Permit Number: 061427

has permission to New Single Family Home w/ car garage

AT 22 STEPPING STONE LN - Lot 8

| ONE AND TWO FAMILY | PLAN REVIEW | CHECKLIST |

LOT 8 - GRADING PLAN
 AUTUMN GLEN SUBDIVISION

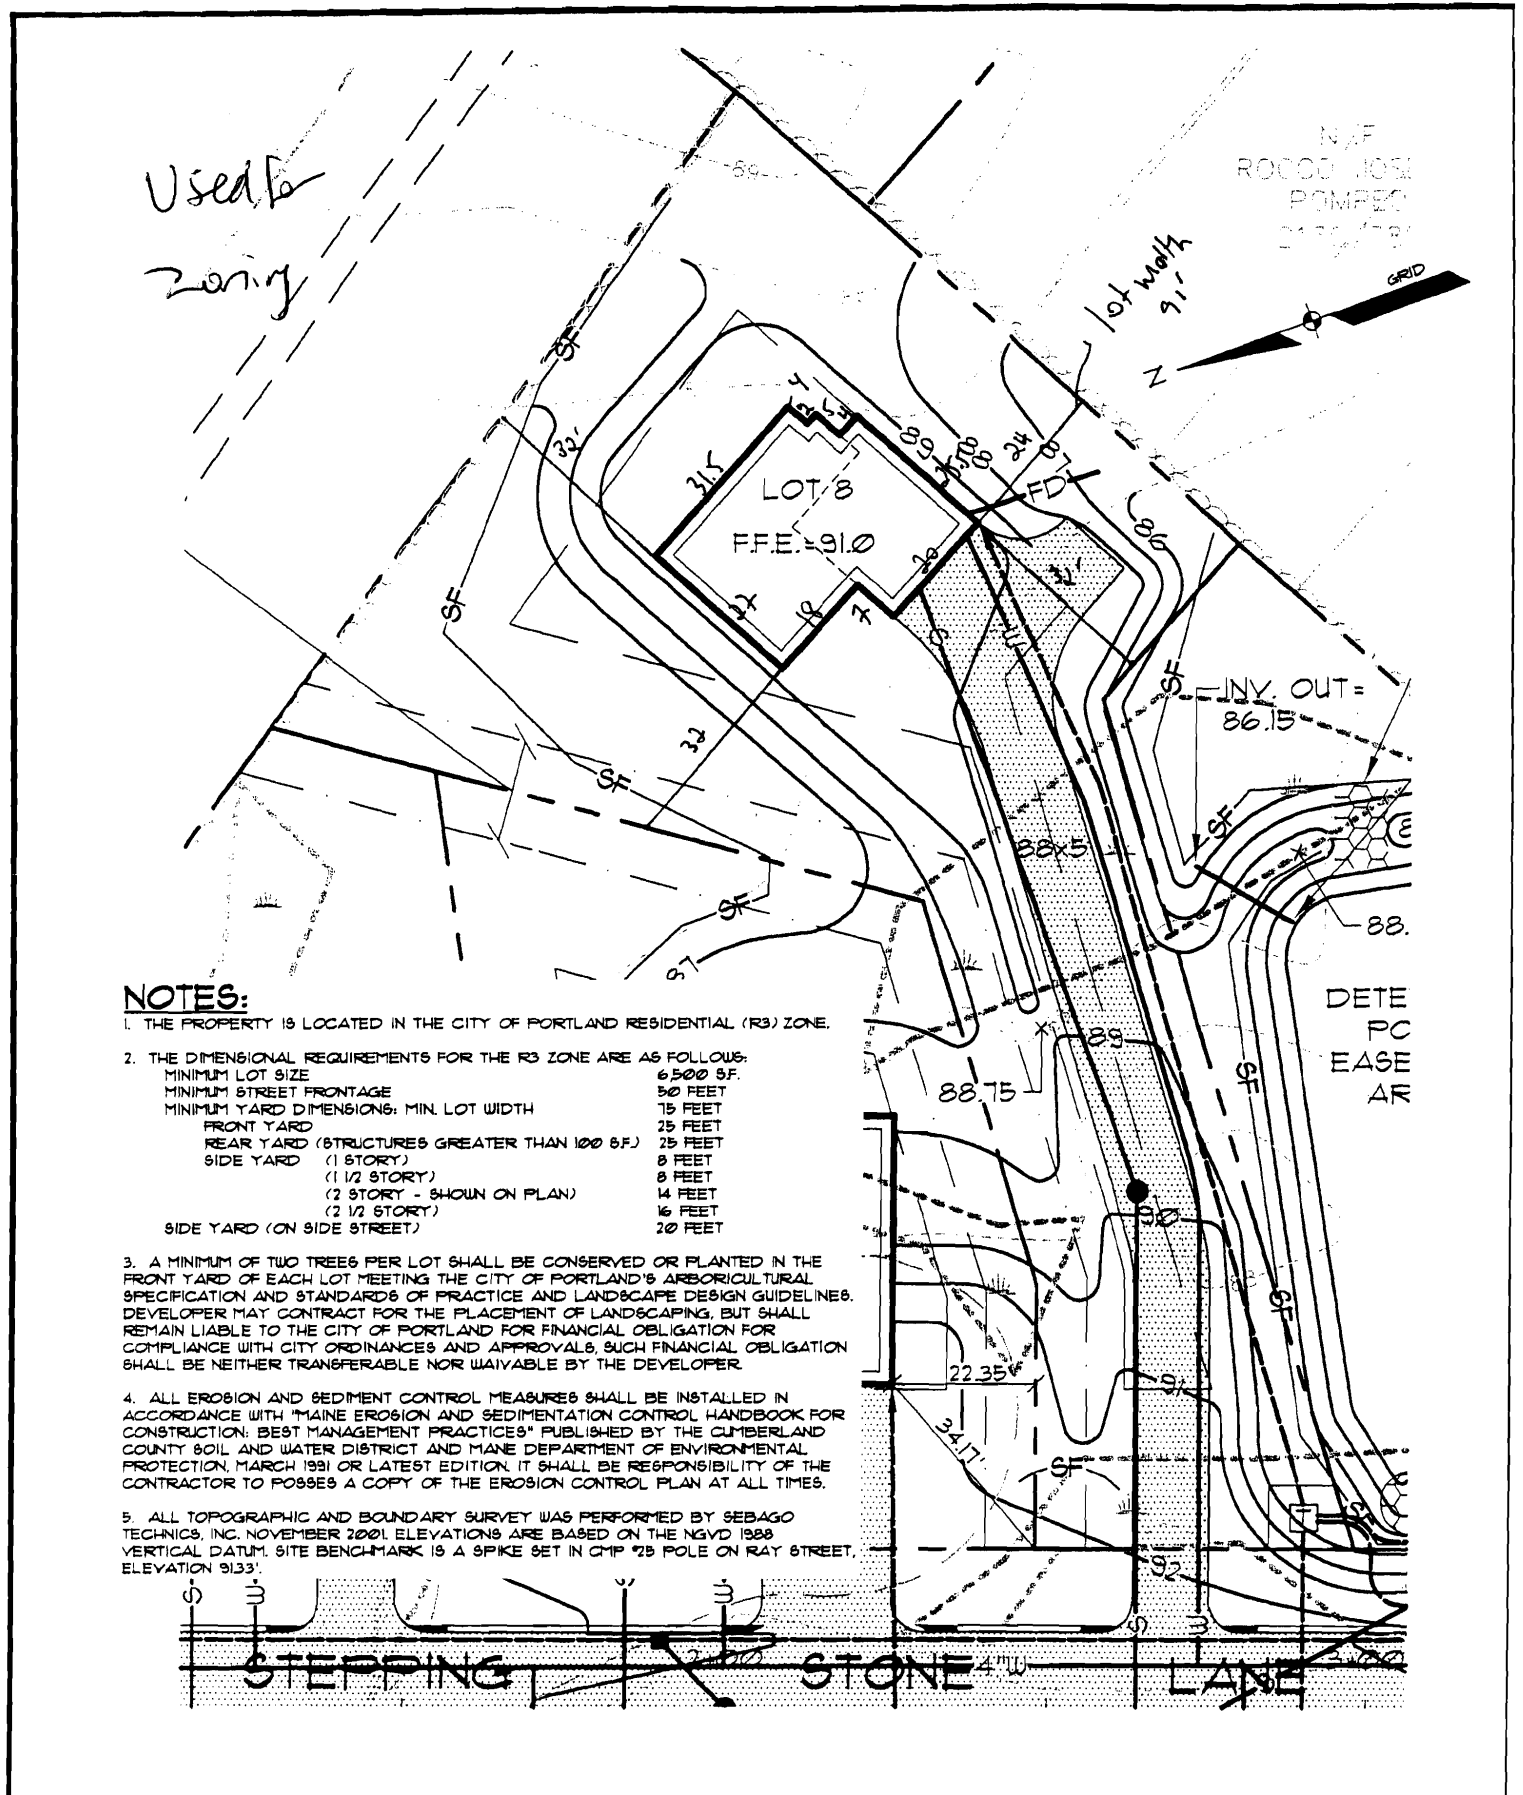
10/4/2006-amachado: Elevation plans show a daylight basement in the rear. This does not match with the grading plan. Left message for King Weinstein to call me.

~~x shows daylight breach but grading does not match~~
no daylight breach

1 STAIR SECTION

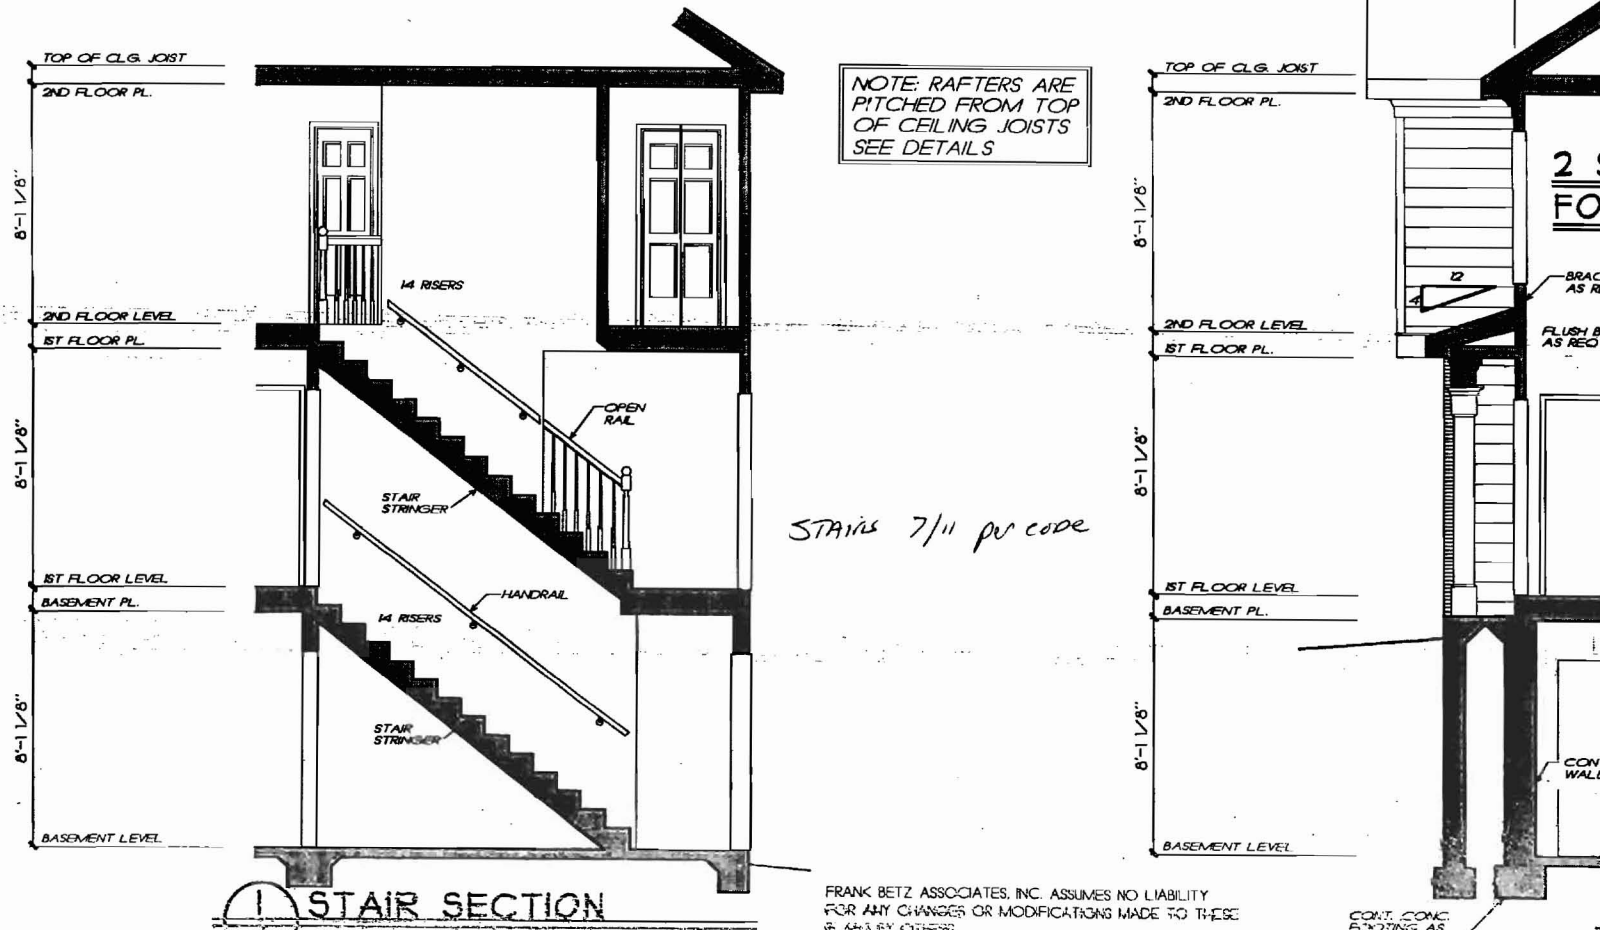
| <p>Means of Egress (Sec R311 & R312) Basement / Number of Stairways / Interior / Exterior 2 Treads and Risers (Section R311.5.3) to CABO - need to IRC - opening size is not large enough Width (Section R311.5.1) 3'-2" Headroom (Section R311.5.2) - not shown RRP Print #6 & #5 Guardrails and Handrails (Section R312 & R311.5.6 - R311.5.6.3) not shown - RRP Print #5</p> | | |

| 15 | Treads and Risers (Section R311.5.3) Width (Section R311.5.1) 3'-2" | to CABO - need to IRC - opening size is not large enough | |

ROOF FRAMING PLAN

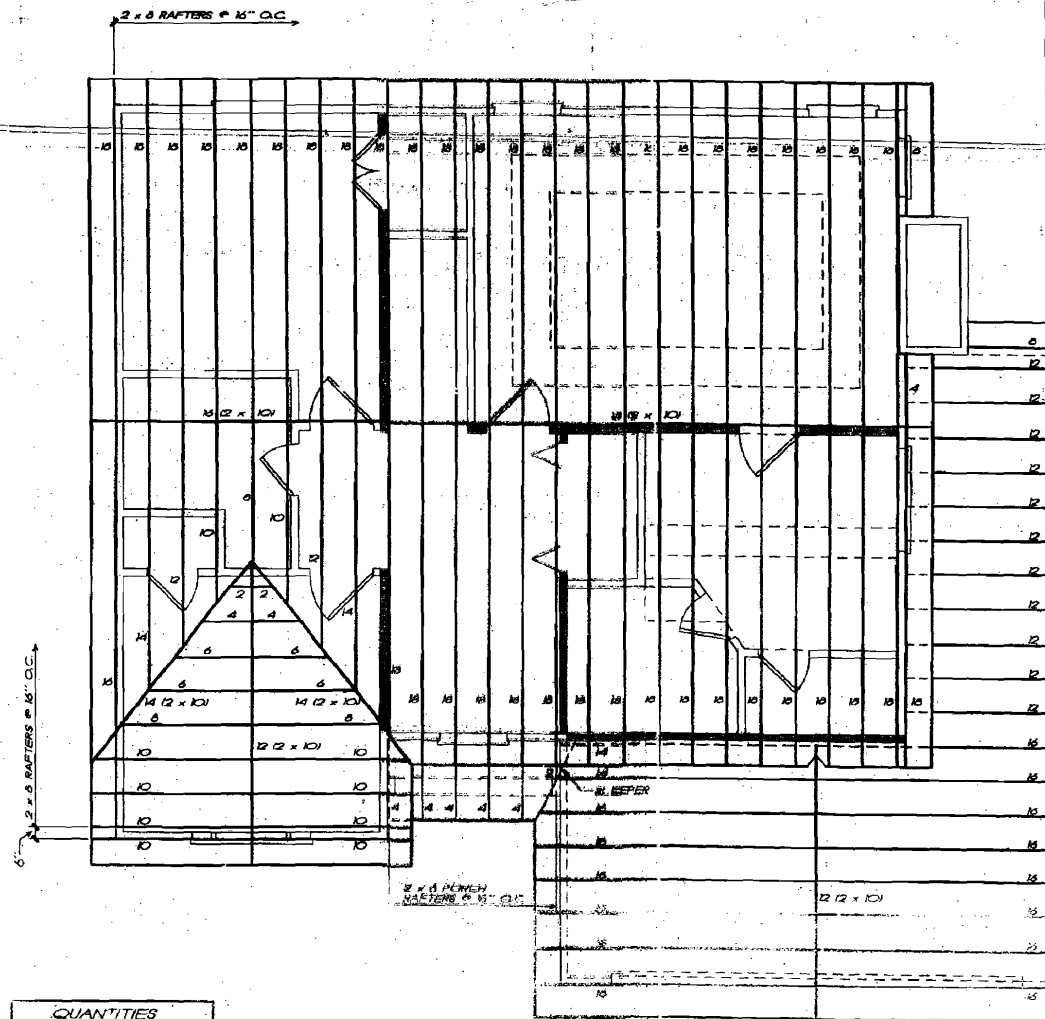
| <p>46 Pitch, Span, Spacing & Dimension (Table R802.5.1(1) - R 802.5.1(8)) Roof Rafter; Framing & Connections (Section R802.3 & R802.3.1)</p> | <p>2x8's note #1 - under sized</p> | |

| 6 | Pitch, Span, Spacing & Dimension (Table R802.5.1(1) - R 802.5.1(8)) Roof Rafter; Framing & Connections (Section R802.3 & R802.3.1) | 2x8's note F1 - under sized | |

- 5) Hardwired interconnected battery backup smoke detectors shall be installed in all bedrooms, protecting the bedrooms, and on every level.
- 6) As discussed, the rafters must be 2" x 10"s.
